Addendum Number One

Drawings and Specifications Dated August 17, 2007

Portland Harbor Hotel Annex

Archetype, P.A.

AD 1.16	ADDENDUM TO SHEET S7	Date 31 August 2007	Scale 1/8" = 1'-0"	ARCHETYPE, P.A. ARCHITECTS <small>48 Union Wharf Portland, Maine 04101 (207) 772-6022 Fax (207) 772-4056</small>
	Project: PORTLAND HARBOR HOTEL ANNEX	STRUCTURAL FRAMING PLAN		
	468-470 FORE STREET PORTLAND, MAINE

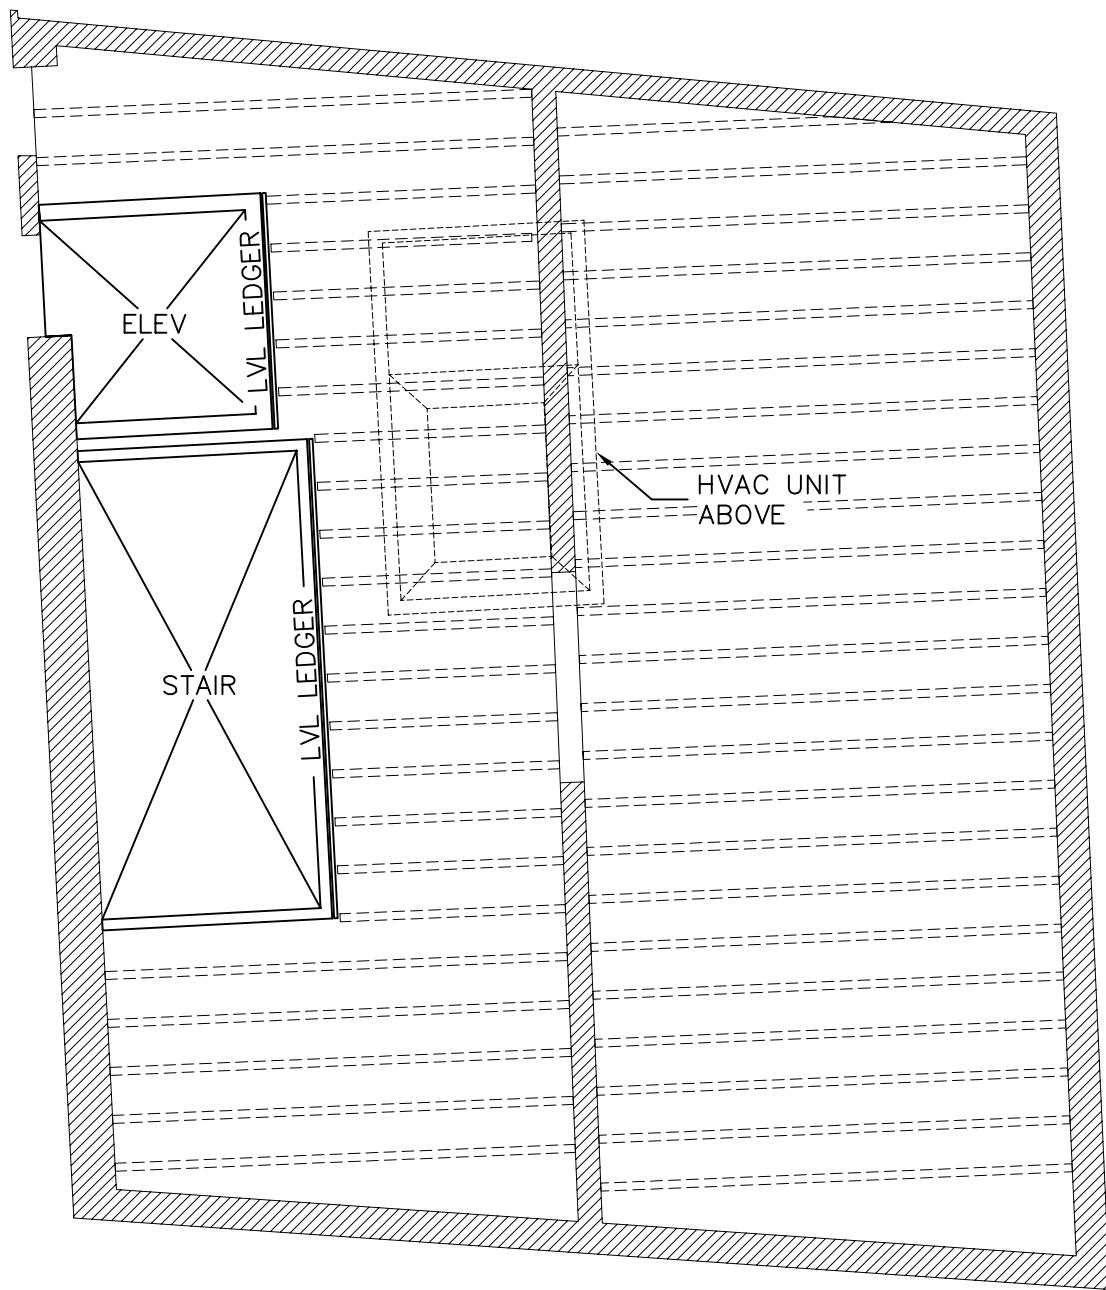
14. **Modification:** Sheets S3 through S7 – Structural Framing Plans; see attached drawings **AD1.12, AD1.13, AD1.14, AD1.15, AD1.16 – Structural Framing Plans** for

23. **Modification:** SHEET S7 - Roof Framing Plan; omit W12x26 spanning from 2-A to 2-C. Add HSS4x4x0.1875 at 2-B. Add W8x10 from 2-A to 2-B.
24. **Modification:** SHEET S9 - Column Schedule & Framing Details; Revise Column Schedule to indicate an HSS4x4x0.1875 at grid 2-B with bottom of Base Plate at elevation 113’-9” and top of column at elevation 146’-7”.

REPLACES FRAMING SHOWN ON S7.
 EXIST FRAMING TO REMAIN SHOWN DASHED.
 ELEV & STAIRWALLS ARE 6", 18 GAGE STEEL STUDS@12".

AD 1.17	ADDENDUM TO SHEET S9	Date 31 August 2007	Scale 1" = 1'-0"	ARCHETYPE, P.A. ARCHITECTS 48 Union Wharf Portland, Maine 04101 (207) 772-6022 Fax (207) 772-4056
	Project: PORTLAND HARBOR HOTEL ANNEX 468-470 FORE STREET PORTLAND, MAINE	STRUCTURAL FRAMING DETAILS

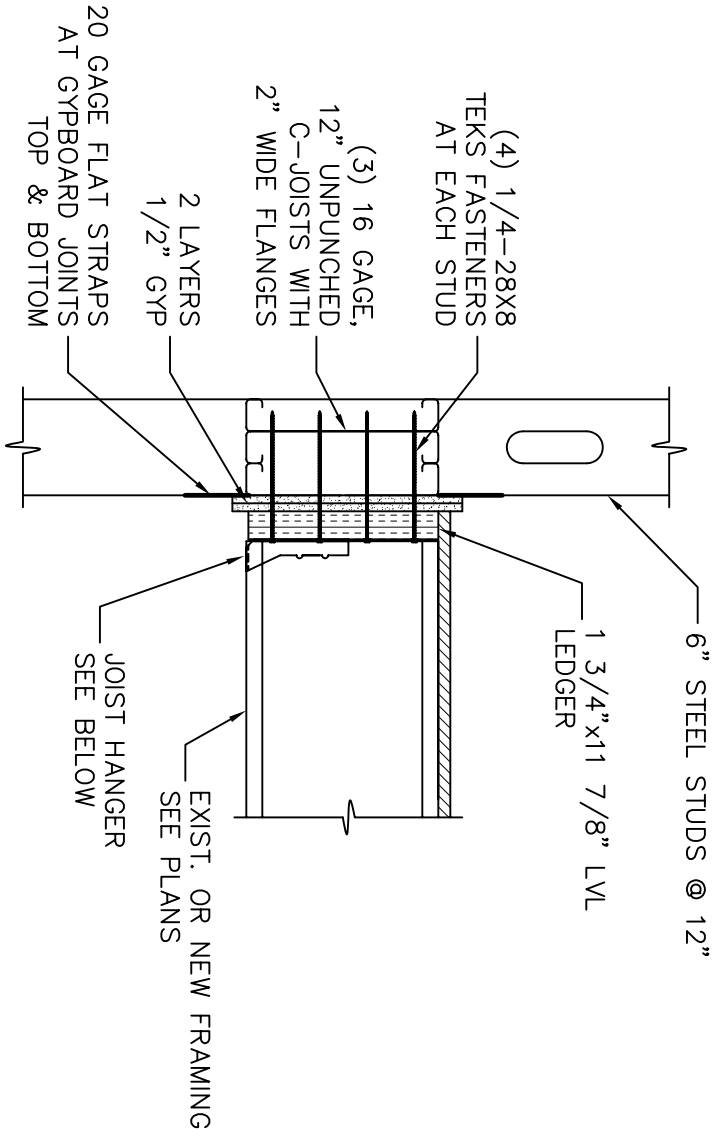
18. **Modification:** Sheet S9 – Structural Framing Details; see attached drawings **AD1.17 – Ledger Detail** and **AD1.18 – Brick Bearing Ledge Detail** for changes to framing details in the renovation and reframing of 470 Fore Street (Akari Building).

Date
 31 August 2007
 Scale
 SEE DETAIL
 SPANDREL DETAIL
 CURTAIN WALL

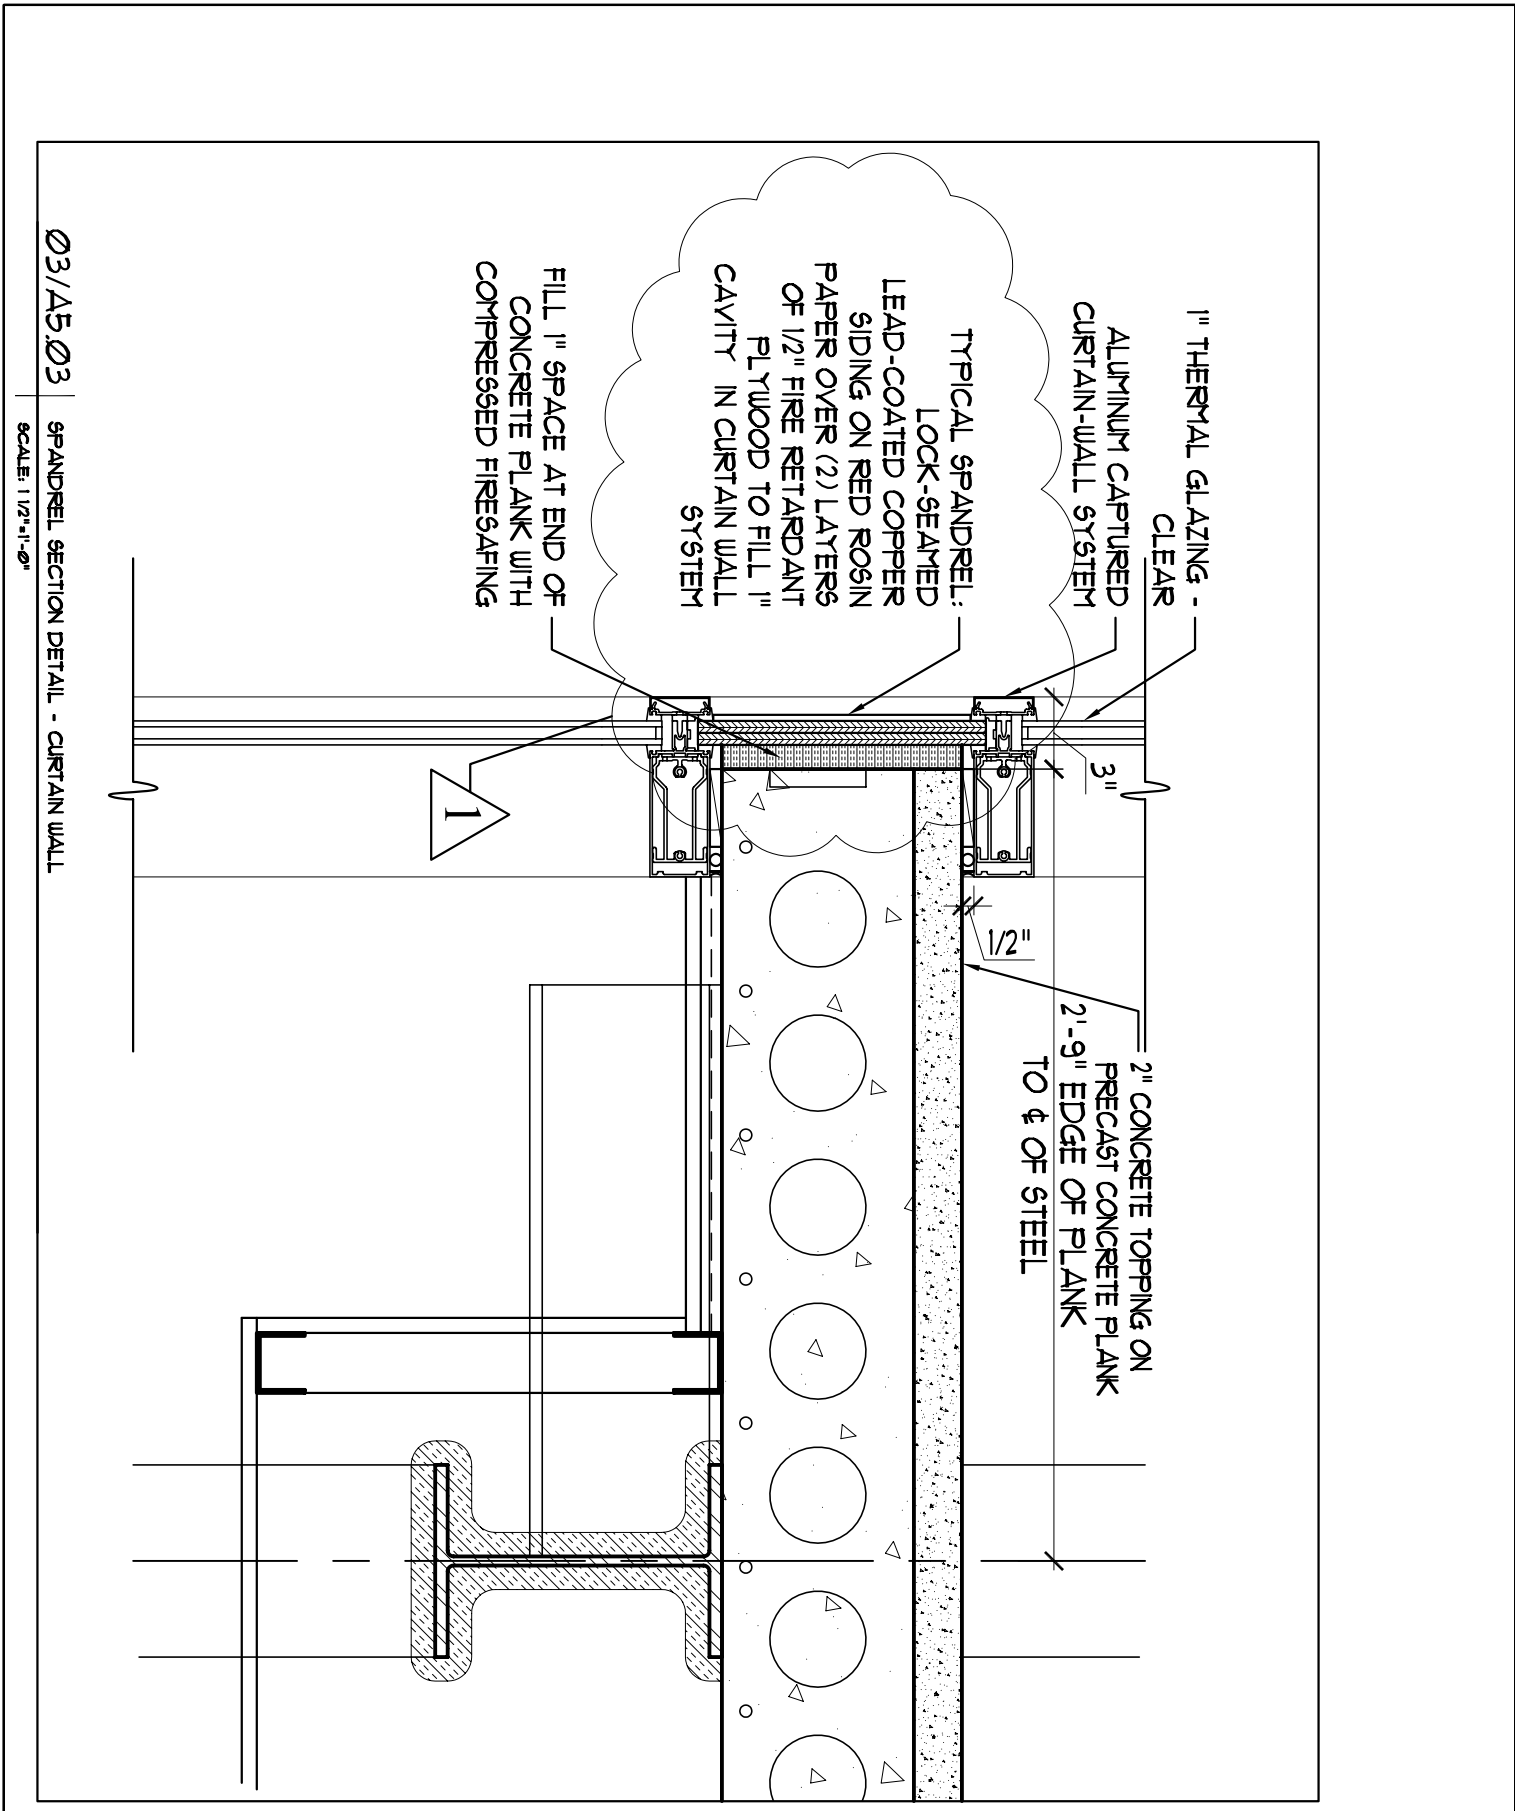
15. **Modification:** Sheet A5.03 – Details; see attached drawing **AD1.19 – Spandrel Panel Curtain Wall** and **AD1.20 – Spandrel Detail at Vestibule Entry** for reference to change the words “cement backer board” to read “(2) layers ½” fire retardant plywood”. The two layers of plywood will be sandwiched together and inserted into the aluminum framing system at the spandrel locations and caulked and sealed into the curtain wall. The lead coated copper shall be attached to the fire retardant plywood between the aluminum mullion caps. See attached Specification Section 06073 – Fire Retardant Treatment “D-Blaze”.

AD 1.21	ADDENDUM TO SHEET S8	Date 31 August 2007	Scale 1/2" = 1'-0"	ARCHETYPE, P.A. ARCHITECTS <small>48 Union Wharf Portland, Maine 04101 (207) 772-6022 Fax (207) 772-4056</small>
	Project: PORTLAND HARBOR HOTEL ANNEX	RETAINING WALL SECTION DETAIL		
	468-470 FORE STREET PORTLAND, MAINE

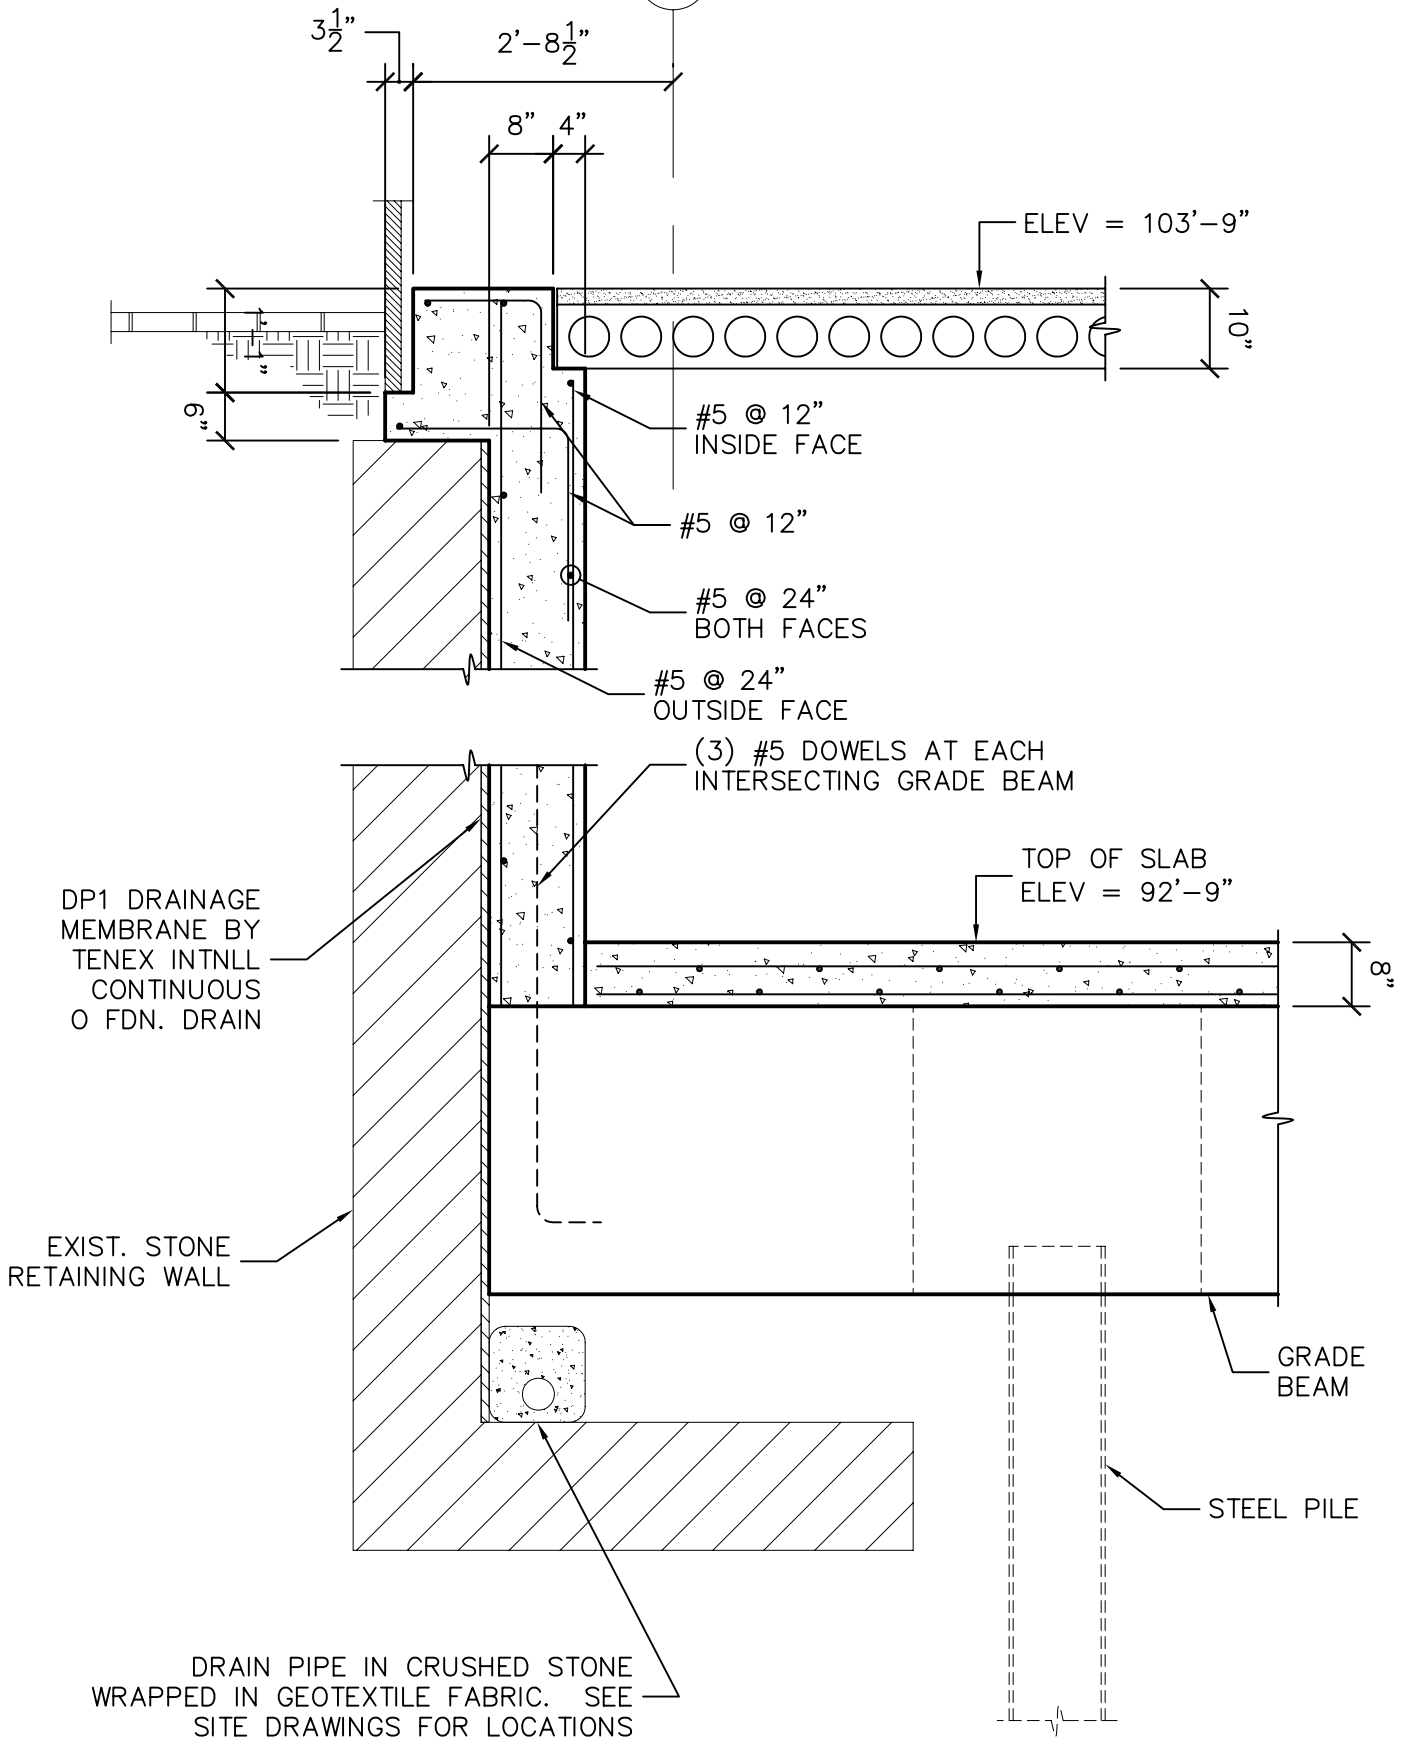
16. **Modification:** Sheet S8 – Foundation Details; see attached drawing **AD1.21 – Retaining Wall Detail** for alteration to detail for the North Retaining Wall and the modification of the drainage material sandwiched between the existing and the new retaining walls.

Q2. I see that 2” rigid board insulation will be used for the foundation waterproofing. Do you know if a drainage composite board will also be used in conjunction with the insulation board? They often are both used. And sometimes it is one or the other.

A. See AD1.21 – Retaining Wall Section Detail for the revised drainage mat at the retaining wall. All other surfaces, that is the foundation walls that extend above grade on the north-east and north-west corners, and the brick masonry walls of 470 Fore St that will be below grade are to receive the waterproofing specified above and described in the attached specification Section 07140.

AD 1.22

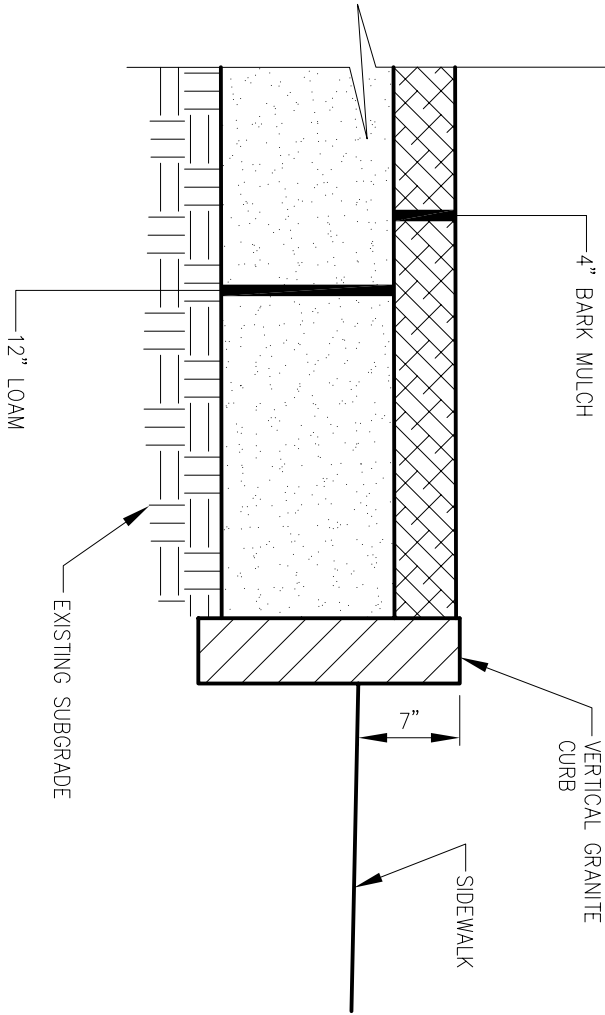
17. **Modification:** Sheet 1 – Site Plans, Existing Conditions and Demolition Plan by DeLUCA Hoffman shall have the following modifications: Contractor shall carry materials and labor for the installation of a 4” perimeter drain around the entirety of the footprint at 468 Fore Street and shall tie this drain into the catch basin at the south of the site. See attached drawing **AD1.22 – Raised Landscape Planter Detail** for materials and construction of the raised planter bed on the West Façade of 470 Fore St. This planter shall have installed a drip irrigation system.

AD 1.21	ADDENDUM TO SHEET S8	Date 31 August 2007	Scale 1 1/2" = 1'-0"	ARCHETYPE, P.A. ARCHITECTS <small>48 Union Wharf Portland, Maine 04101 (207) 772-6022 Fax (207) 772-4056</small>
	Project: PORTLAND HARBOR HOTEL ANNEX	COLUMN SPLICE DETAIL		
	<small>468-470 FORE STREET PORTLAND, MAINE</small>

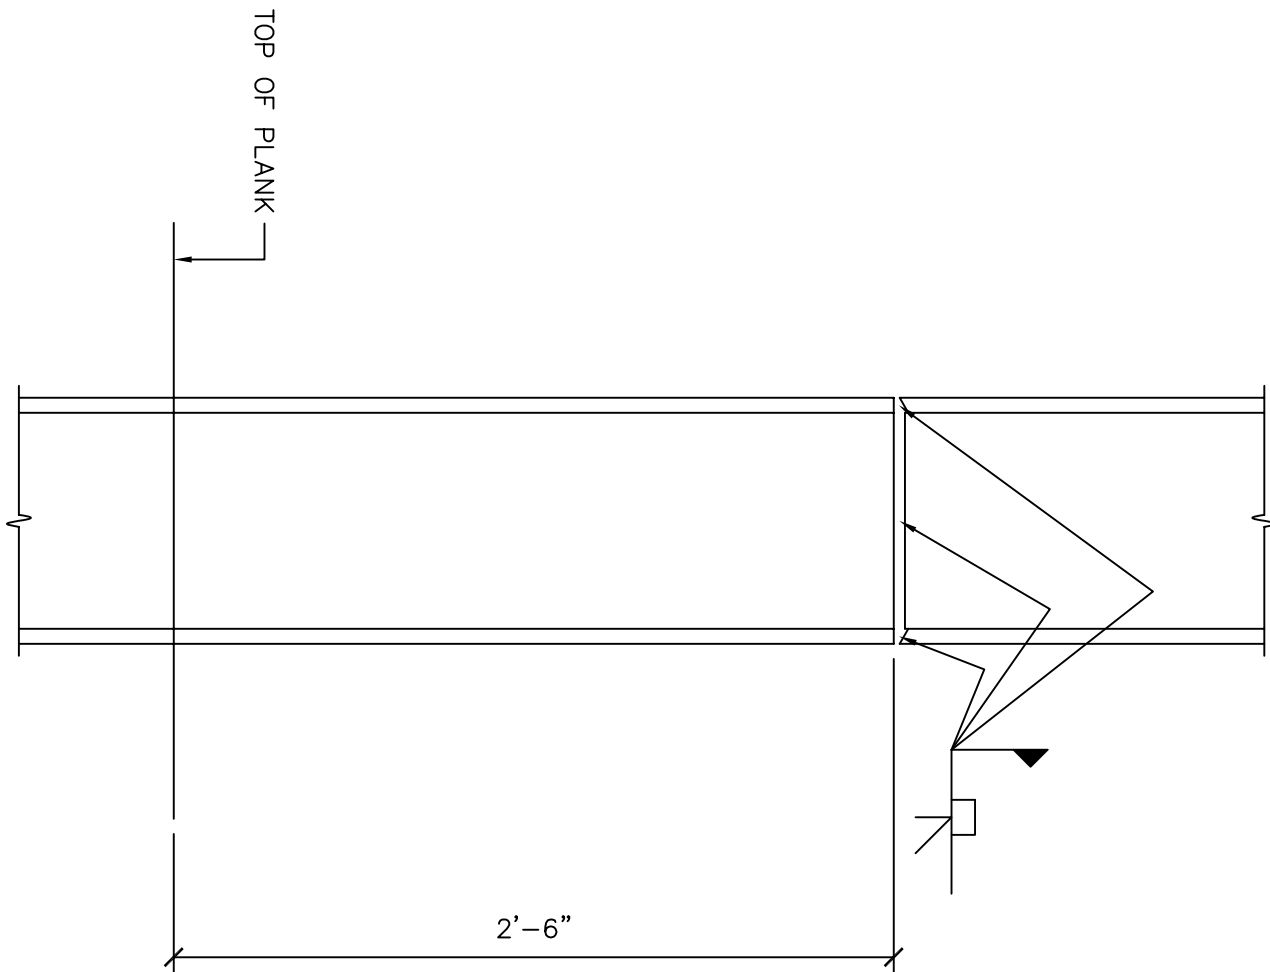
19. **Modification:** Sheet A7.01 – Schedules; see attached sheet **AD1.23 – Finish Schedule** for extent of painting in existing and new spaces.
20. **Clarification:** Sheet S9 – Structural Framing Details; see attached drawings **AD1.24 – Column Splice Detail** for detail.
